BC Ambulance Service BC Emergency Health Services	321-15	January 5, 2016 Page 1 of 4
AMBULANCE TYPE:	DEMERS FIRST YEAR DUAL STRETCHER	
UNITS AFFECTED:	63080 TO 63092

ISSUE: THE POSITIONING OF THE YELLOW SAFETY HOOKS ON THE FIRST YEAR DEMERS DUAL STRETCHER AMBULANCES MAY RESULT IN THE HOOKS NOT CATCHING CORRECTLY WHEN LOADING OR UNLOADING COTS. THE ISSUE MAY ARISE WHEN THE COT STRADDLES BOTH HOOKS, WHERE ONE HOOK WILL RAISE THE STRETCHER CATCH BAR MISSING THE SECOND HOOK.

ACTION: RELOCATE THE RIGHT SAFETY HOOK & SEAL THE PREVIOUS HOLES APPROPRIATELY.

Figure 2

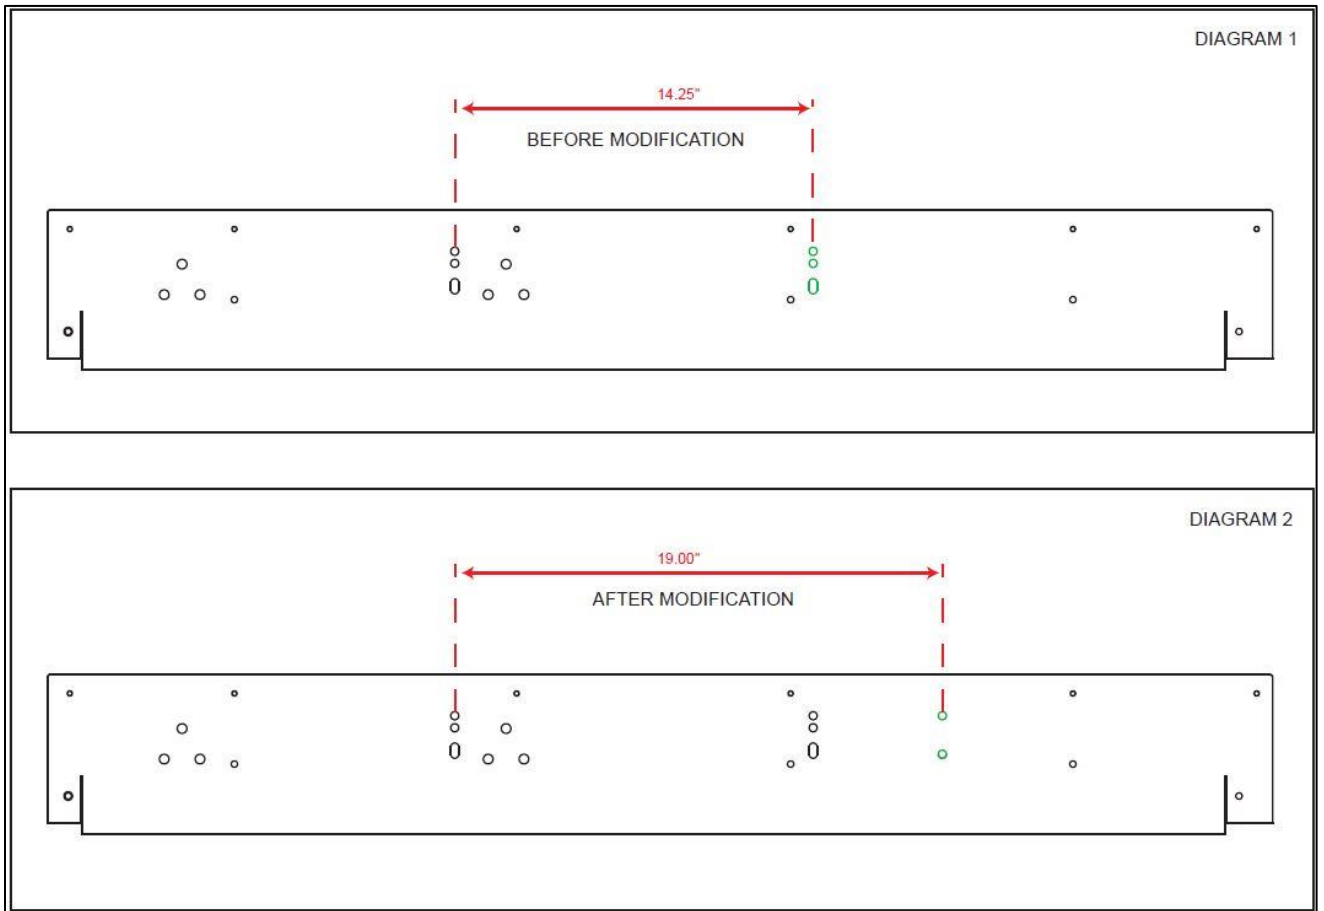
2. Remove silicone to have access to the bolts.
3. Remove bolts holding the safety hooks. The retaining Nuts are located under the vehicle.
4. Refer to Figure 2 below for the new mounting location of the safety hook.

5. Drill 5/16 inch hole at the new location as per Figure 2.
6. Reinstall safety hook in the new location using the original mounting hardware.
7. Using Sikaflex #221 (White) urethane seal the previous holes.

Figure 3

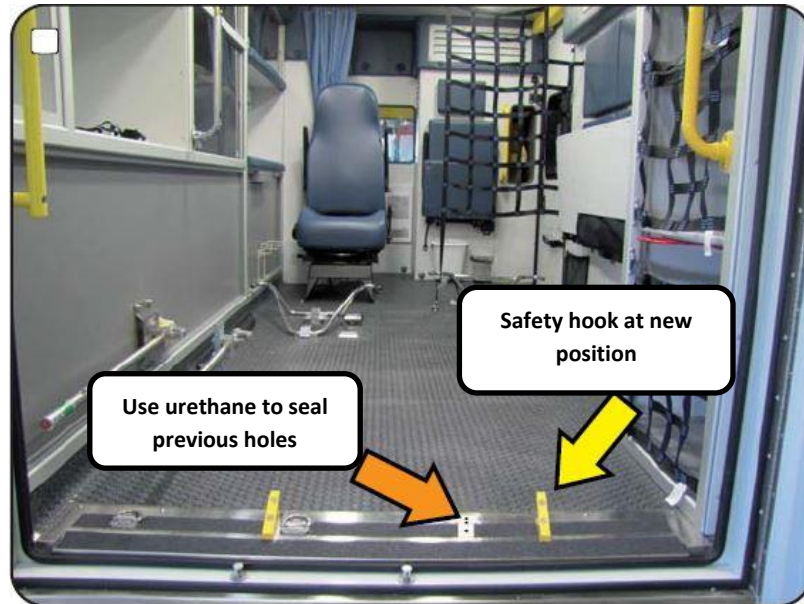
8. Inspect from the underside and ensure that the urethane is applied all the way through to the floor. The urethane being white in color should be easily visible from the underside.

IMPORTANT: If there is a gap under the vehicle that shows some plywood, moisture will catch and it will rot.

Figure 4

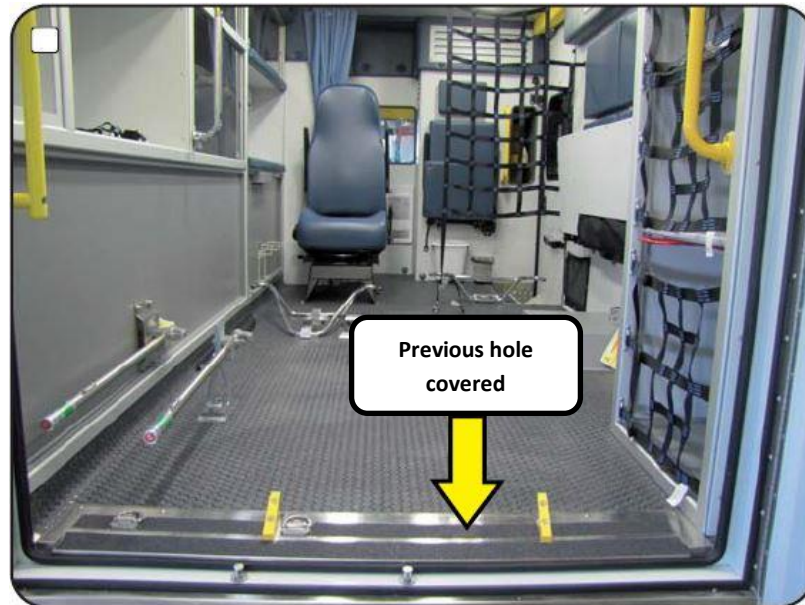
10. Install anti-skid tape and to ensure the previous holes are appropriately covered.
